RECEIPT DATE: 2/4/22 **ONSITE SEWAGE DISPOSAL SYSTEM** P 570944
 APPROVAL DATE: 6/9/22 (50) **PERMIT: CONSTRUCTION** A _____
 PROPERTY ADDRESS: 3651 FOLLY QUARTER ROAD, ELLICOTT CITY, MD 21042
 SUBDIVISION: FOXLEIGH (frmr. HYMAN PROPERTY, Parcel 140) LOT: ---- TAX ID: 03-340627
 CONTRACTOR: WTC CONTRACTORS, INC. EMAIL: _____
 CONTRACTOR ADDRESS: 3033 SALEM BOTTOM ROAD, WESTMINSTER, MD 21157 PHONE: (410)875-9771
 PROPERTY OWNER: CBI HOMES, LLC EMAIL: pwalter@catonsvillehomes.com
 OWNER ADDRESS: 11175 STRATFIELD COURT, MARRIOTTSVILLE, MD 21104 PHONE: (410)442-2215
 SEPTIC TANK SIZE (GALLONS): 2000 TANK MANUFACTURER: TBD
 PUMP MODEL: GOULDS WE-10H PUMP SIZE 1.0 Hp PUMP TANK CAPACITY: 1500

ANTI-FLOTATION COMPUTATIONS
FOR
FOXLEIGH PARCEL 140
SEPTIC TANK & PUMP TANK

From: Silvast, Zackary
Sent: Wednesday, March 9, 2022 12:42 PM
To: ron@vanmar.com
Cc: Williams, Jeffrey; Wolf, Kevin; Bricker, Robert
Subject: regarding Foxleigh/Hyman Property - 3651 Folly Quarter Ln

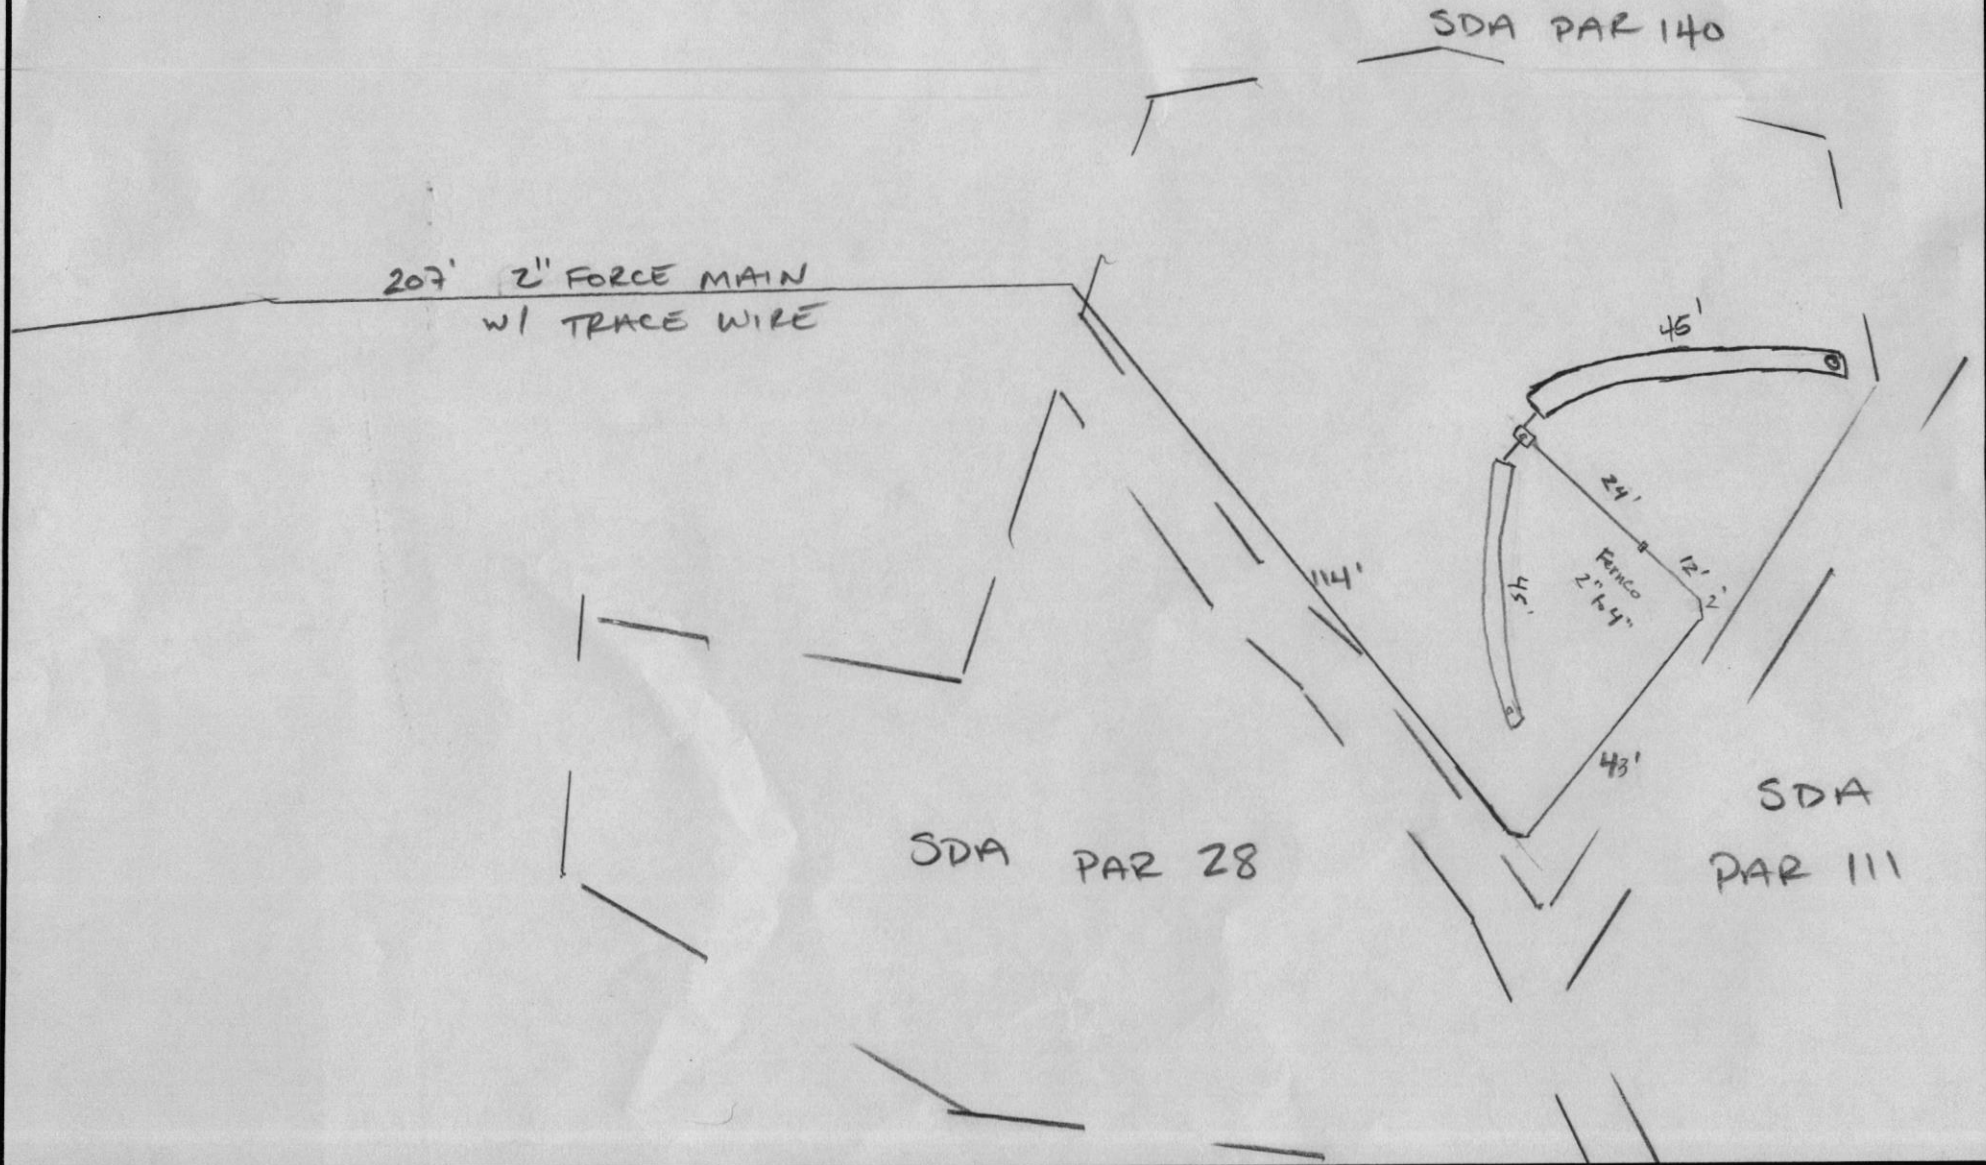
02/28/2022 Tank locations CONFIRMED. CONFIRMED ANCHORING AND WATER TIGHT TEST. CONFIRMED 2 x 44' TRS ON CONTOUR. Ⓢ

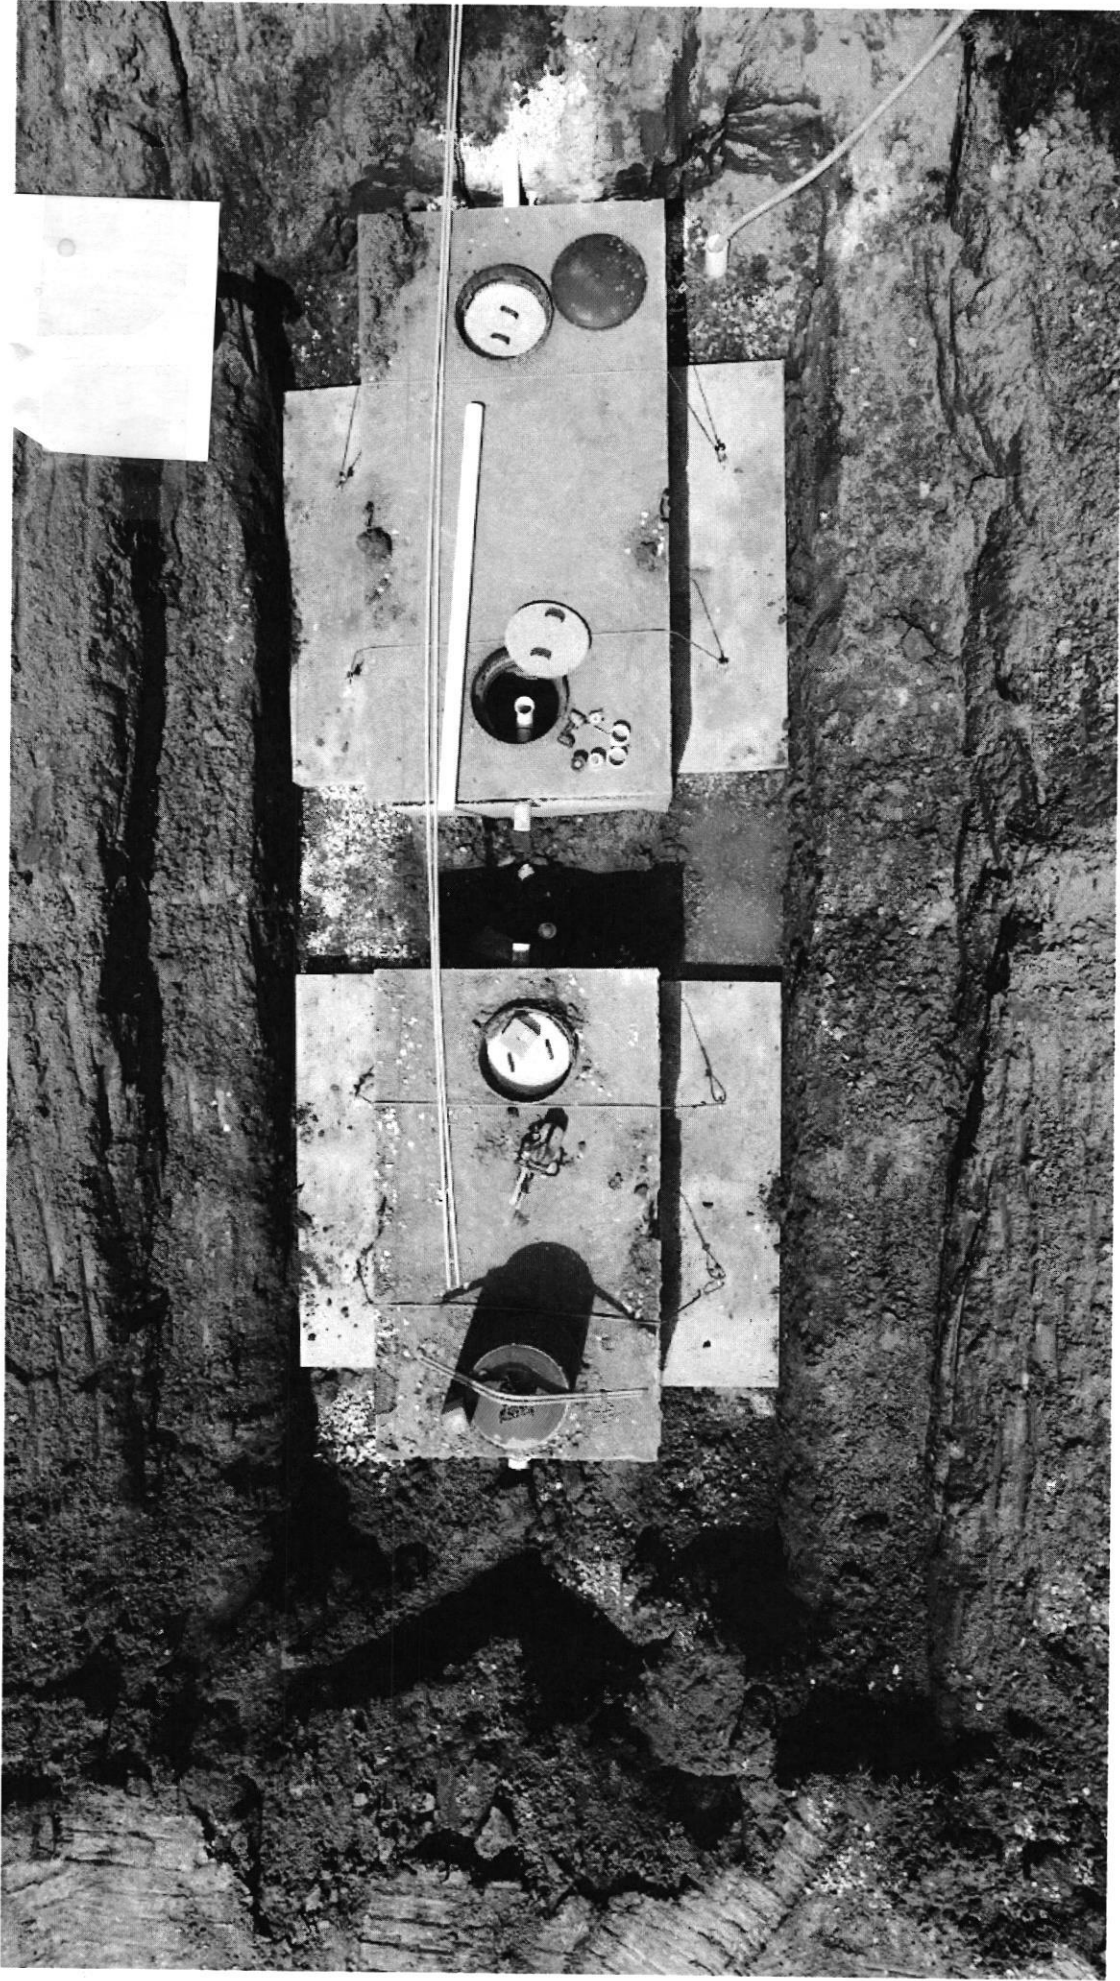
03/01/2022 INSTALLED FORCE MAIN W TRACE TAPE; INSTALLED SEWER LINE + SHC. Ⓢ 3/2/22 Installed force main changing from 2" to 4" pipe (via Fernco) as it falls to box. 1 x 45' trench installed. D-box set Ⓢ
 03/03/2022 TRS COMPLETE; TANKS SET. Ⓢ 3/4/22 Vacuum tests conducted on both tanks. Pump tank held 5" and 5.3" mercury on two different gauges from 10:20-10:25 AM. Septic tank held 4" and 5" of mercury on different gauges from 10:52-10:57 AM. Both tanks have normal 4" lids. Tanks have additional tar around lids. Ⓢ
 04/21/2022 TANKS RELOCATED & ANCHORED. Ⓢ 06/09/2022 PIA OK. Ⓢ

04/21/2022
3651 FOLLY QUARTER ROAD
TANK RELOCATION
POST PRESSURE TEST

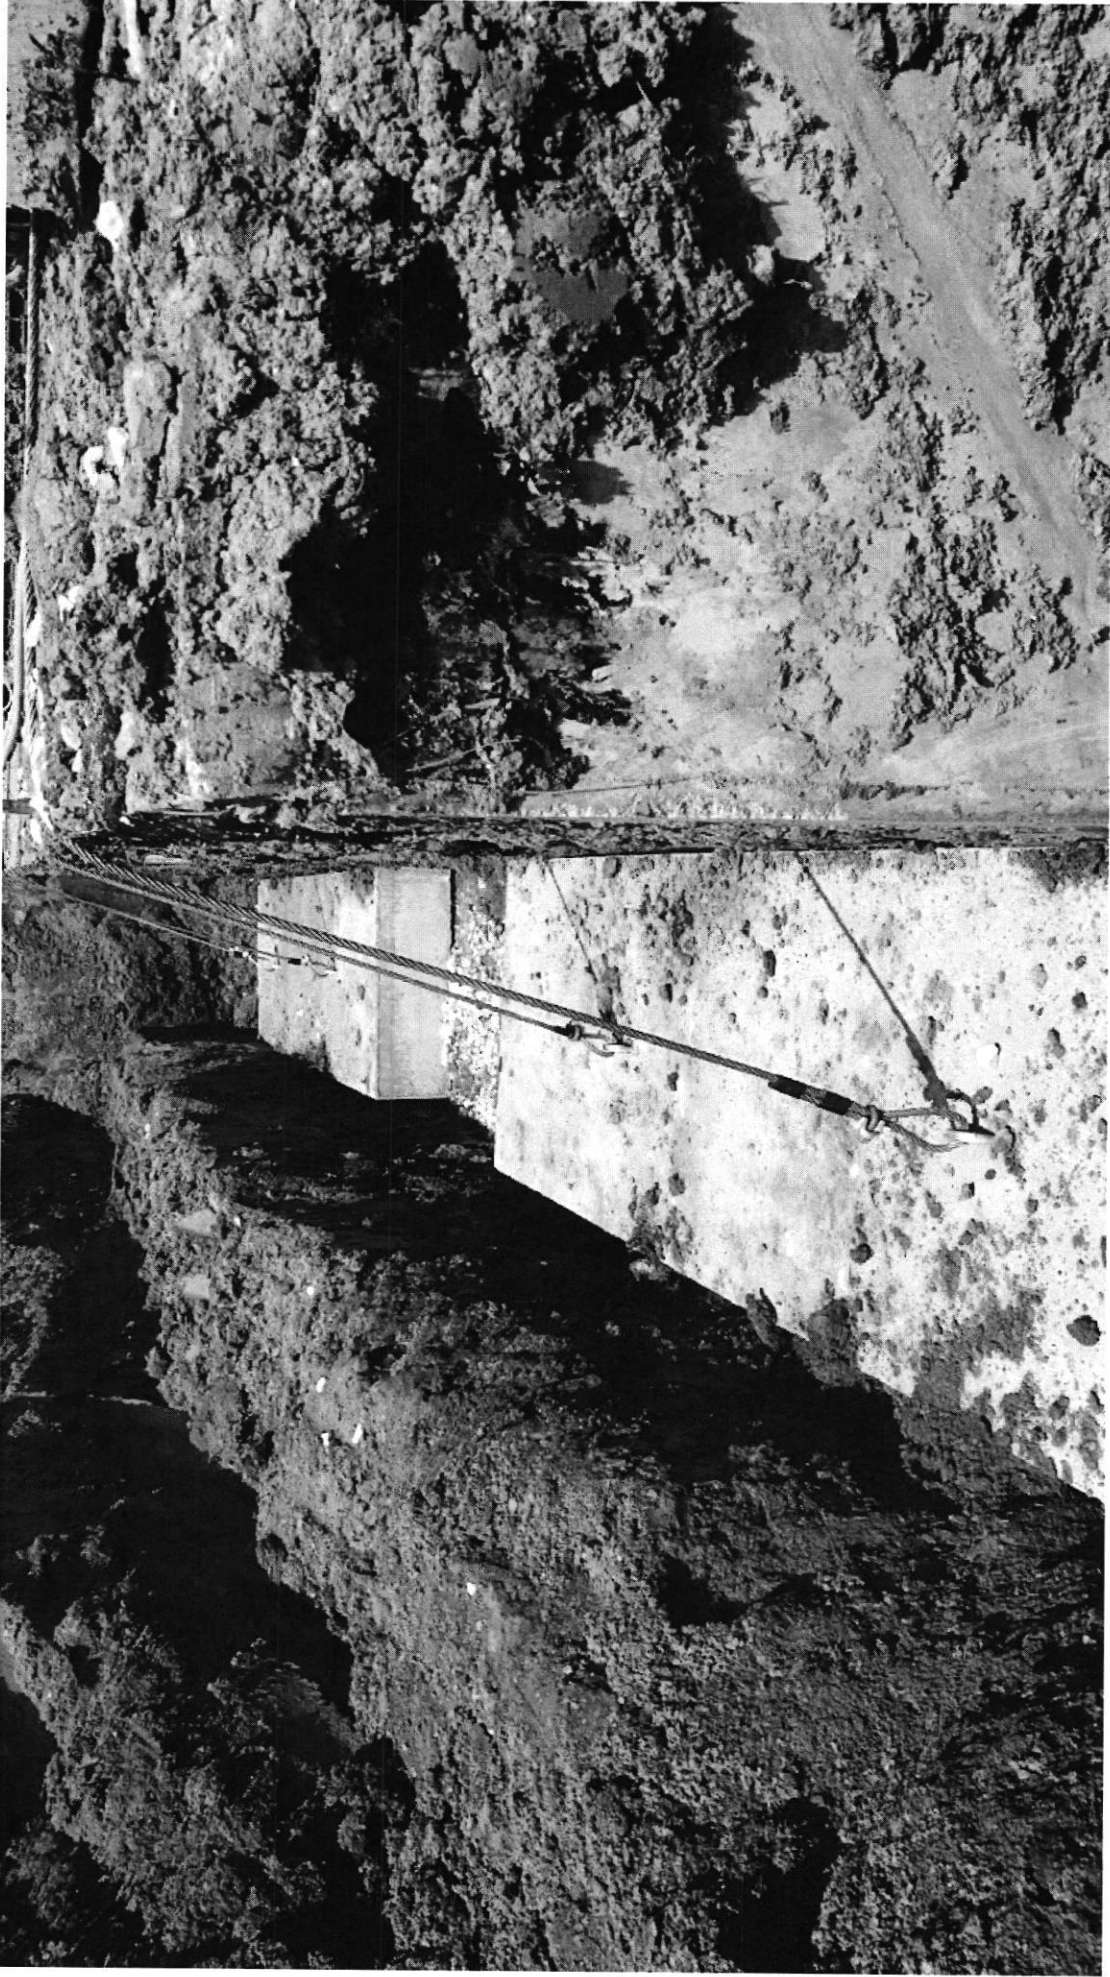
04/21/2022
3651 FOLLY QUARTER ROAD
TANK ANCHOR RIGHT
(PUMP TANK OUTLET)

04/21/2022
3651 FOLLY QUARTER ROAD
TANK ANCHOR LEFT
(PUMP TANK OUTLET)
